Owner Service Advisory SA 08-03

SUBJECT: Release of Tornado Alley Turbo Service Bulletin TAT SB08-01

Service Bulletin

TAT SB08-01

Figure 1. Right side shown.
Left Side Similar.

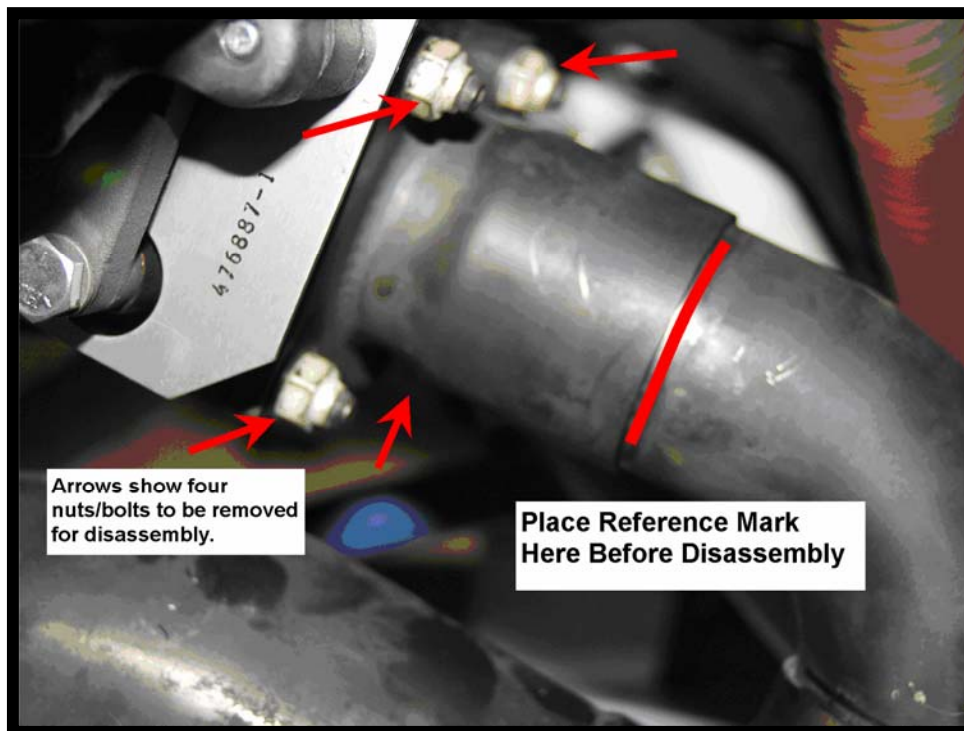
This Service Bulletin contains procedures to modify the right hand exhaust elbow (Group A) and both the right hand and the left hand exhaust elbow (Group B). This exhaust elbow is inserted between the tailpipe and the wastegate outlet fitting. See Figures 1 & 2.

- b. Visually locate the wastegate outlet on the aft side of the right hand wastegate. See Figure 1. Disconnect the heater hose clamp and hose from the intercooler to facilitate inspection and access.

- c. Visually inspect the right angle exhaust elbow and the area where the elbow inserts into the tailpipe, for any signs of a crack in the weld of the vertical receptacle in the tailpipe into which the short leg of the right angle elbow is inserted. If any cracks are observed, then contact Tornado Alley Turbo, Inc. for replacement parts before return to service or further flight.

- i. Measure the length of the elbow from the previously applied reference mark to the end of the long leg of the elbow.
 - j. If this measurement is greater than 1.00", shorten the elbow so that the engagement, when re-installed, will be no more than 1.10" and not less than 1.00" as measured from the reference mark.

- k. If the engagement length is less than 1.00" but is more than 0.90" then simply re-install the elbow. If the engagement is less than 0.90" then contact Tornado Alley Turbo, Inc., for a replacement elbow.

Figure 2.
Left side.
Showing where to place reference mark before disassembly.

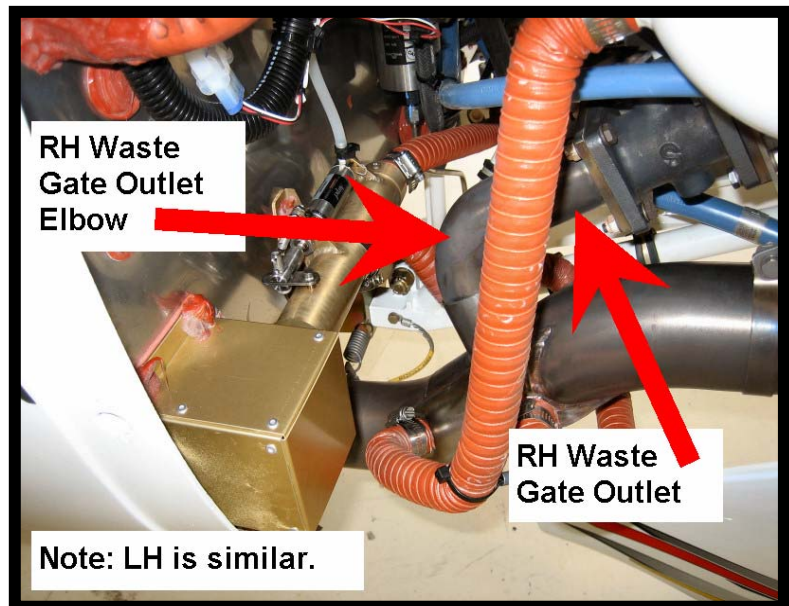
- d. Clean the area where the elbow is inserted into the wastegate outlet tube.
 - e. Mark the exhaust elbow at the aft end of the wastegate outlet tube.

- h. Remove the exhaust elbow from the wastegate outlet swaged tube and clean any exhaust residue from the elbow and wastegate outlet tube assembly. **Be careful to preserve the previously applied reference mark.**
